# UNITED STATES PATENT AND TRADEMARK OFFICE

APPLICATION NO.	FILING DATE	FIRST NAMED INVENTOR	ATTORNEY DOCKET NO.	CONFIRMATION NO.
10/709,661	05/20/2004	Bertil Jonsson	07589.0175.PCUS00	3039
28694	7590	12/14/2004	EXAMINER	
TRACY W. DRUCE, ESQ. NOVAK DRUCE & QUIGG LLP 1615 L STREET NW SUITE 850 WASHINGTON, DC 20036			RODRIGUEZ, WILLIAM H	
			ART UNIT	PAPER NUMBER
			3746

The following title is suggested: --A device for a combustion chamber in a gas turbine for controlling the intake of gas to a combustion zone--.

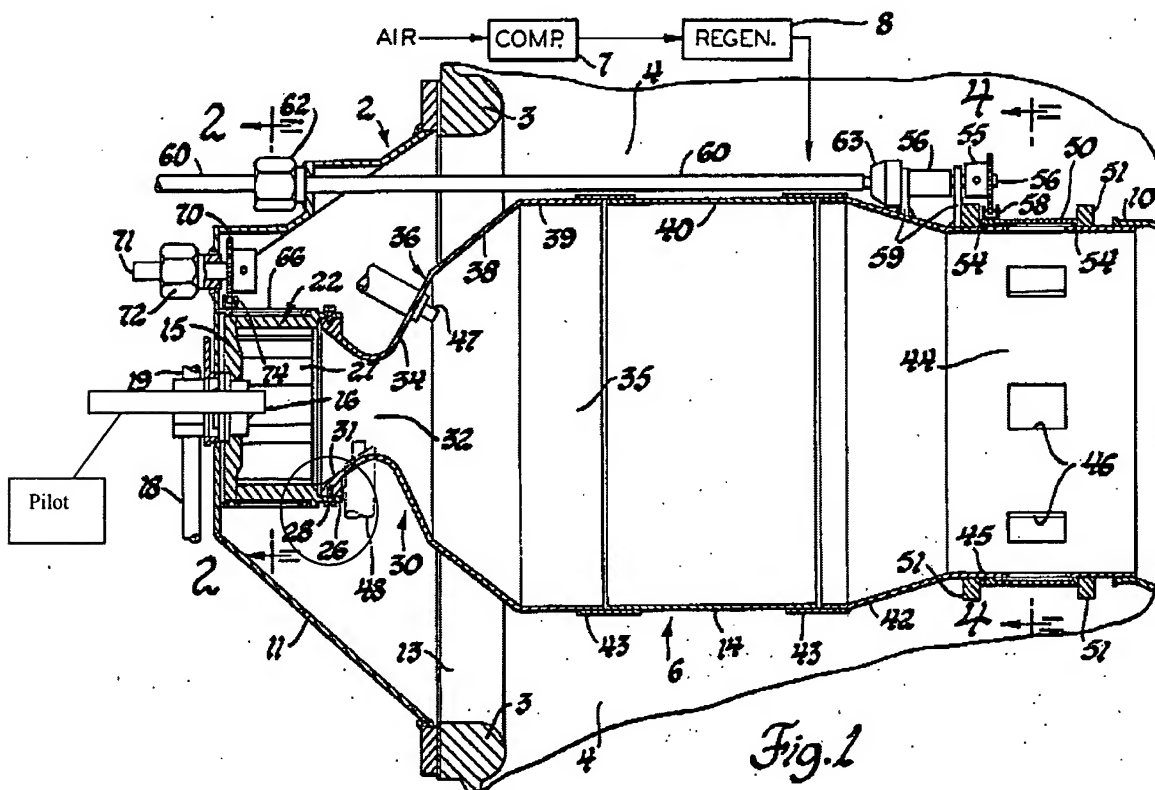
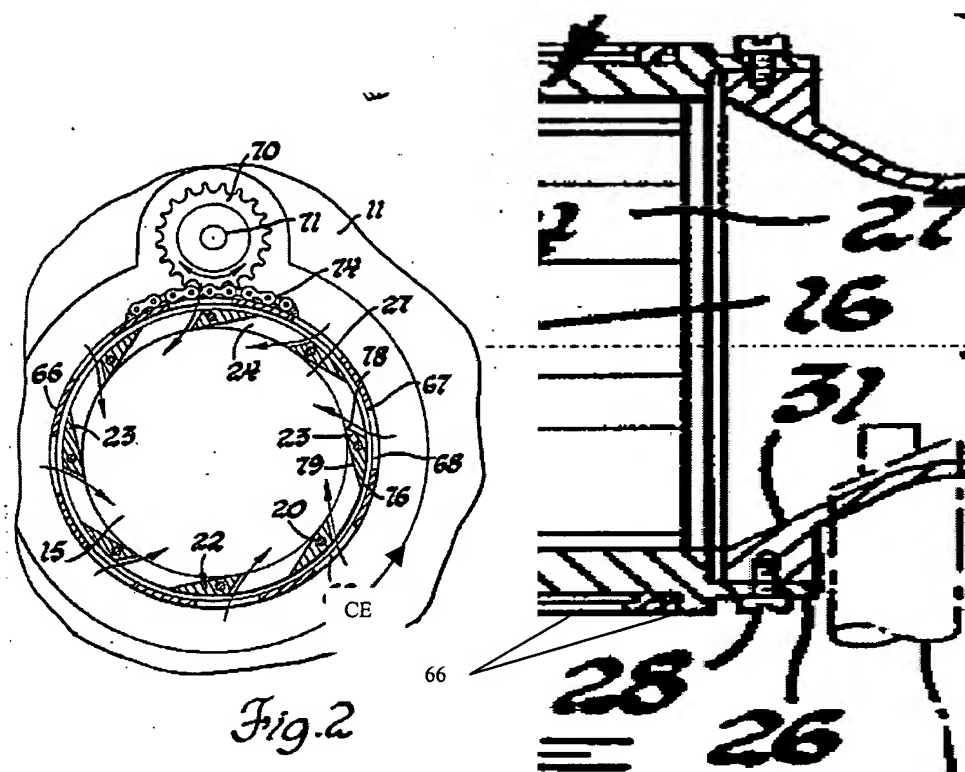
With respect to claim 1, **Cornelius** teaches a device for a combustion chamber (2) in a gas turbine for controlling the intake of gas to a combustion zone of the combustion chamber, said device comprising: a control element CE arranged outside the combustion chamber, said control element further comprising a cover means (66) for covering at least a first inlet 24 to the combustion zone, said cover means 66 being displaceable relative to the combustion chamber, and a support means (31) for the control element which is connected to the cover means 66, said support means (31) being accommodated in a structure (26) at a rear of the combustion chamber. See particularly **Figures 1, 2** of **Cornelius**.

With respect to claim 2, **Cornelius** teaches that the structure 26 in which the support means 31 is accommodated forms at least part of the cover means 66. See sectional view of **Figure 1** above.

With respect to claim 3, **Cornelius** teaches that the structure 26 in which the support means 31 is accommodated is predominately concentrically oriented with a centerline of the combustion chamber. See sectional view of **Figure 1** above.

With respect to claim 4, **Cornelius** teaches that the structure 26 in which the support means 31 is accommodated is radially oriented outside a pilot distributor (not shown but inherent feature in a combustion chamber) to the combustion chamber. See particularly **Figure 1** of **Cornelius**.

With respect to claim 6, **Cornelius** teaches the structure 26 in which the support means 31 is accommodated has a circular cross-sectional shape. See particularly **Figure 1** of **Cornelius**.

With respect to claim 7, **Cornelius** teaches that the cover means 66 has at least one recess 68 extending predominantly in a radial direction through a wall thereof. See particularly **Figure 2** of **Cornelius**.

With respect to claim 8, **Cornelius** teaches the recess 68 in the cover means 66 is arranged together with the first inlet 24 to the combustion chamber thereby establishing a through-duct for gas from a location outside the combustion chamber to a location inside the combustion chamber. See particularly **Figure 2** of **Cornelius**.

With respect to claim 11, **Cornelius** teaches that the cover means 66 is ring-shaped with recess 68 extending through the wall of the ring. See particularly **Figure 2** of **Cornelius**.

With respect to claim 13, **Cornelius** teaches that the support means 31 and the cover mean 66 are fixed to one another (through the structure 26 and bolts 28). See particularly **Figure 1** of **Cornelius**.

With respect to claim 14, **Cornelius** teaches that the control element is rotatable relative to the structure. See particularly **Figure 1** of **Cornelius**.

With respect to claim 15, **Cornelius** teaches that the cover means 66 is arranged at a greater radial distance from a central axis through the control element than is the means of support 31. See particularly **Figure 1** of **Cornelius**.

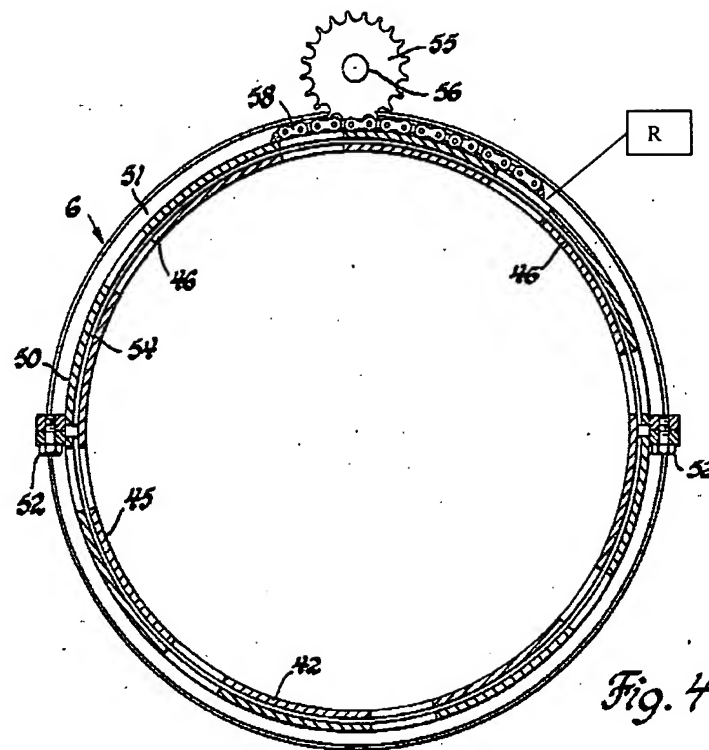
With respect to claim 12, **Cornelius** teaches that the cover means 66 is rotatable in relation to the combustion chamber wall 22. See particularly **Figures 2, 3** of **Cornelius**.

With respect to claim 17, **Cornelius** teaches that the control element further comprises a second cover means (50) configured to cover at least a second inlet to the combustion zone, the second inlet being arranged at a distance from the first inlet in the longitudinal direction of the combustion chamber. See particularly **Figures 1, 4** of **Cornelius**.

With respect to claim 18, **Cornelius** teaches that the second cover means 50 has at least one recess R which extends at least largely in a radial direction through the wall thereof. See particularly **Figure 4** of **Cornelius**.

With respect to claim 19, **Cornelius** teaches that the at least one recess R in the second cover means 50 is arranged, together with the second inlet 46 to the combustion chamber, to form a through-duct for gas from a location outside the combustion chamber to a location inside the combustion chamber. See particularly **Figure 4** of **Cornelius**.

With respect to claim 20, **Cornelius** teaches that the second cover means 50 is ring shaped and the recess R extends through a wall of the ring. See particularly **Figure 4** of **Cornelius**.

With respect to claim 21, **Cornelius** teaches that the second cover means 50 is rotatable relative to the combustion chamber wall 45. See particularly **Figure 4** of **Cornelius**.

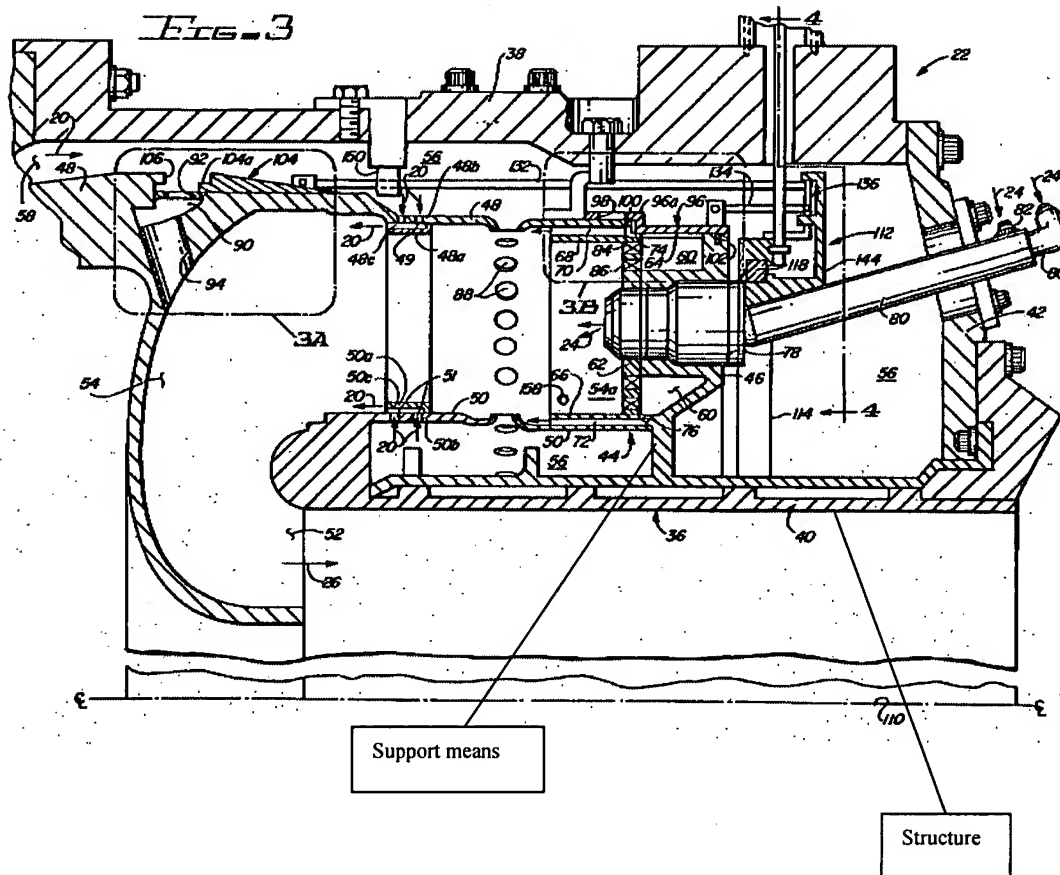
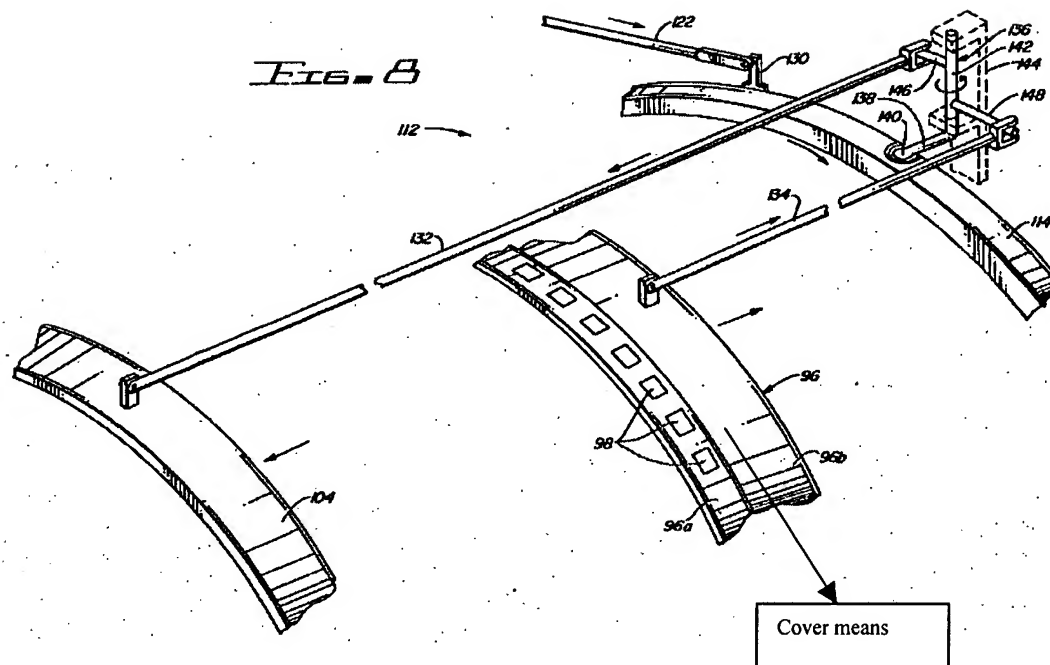
11. The prior art made of record and not relied upon is considered pertinent to applicant's disclosure. U.S. reference 4,532,762 can be used to reject at least claim 1 under 35 U.S.C. 102 (b). See particularly Figures 3, 8 below.
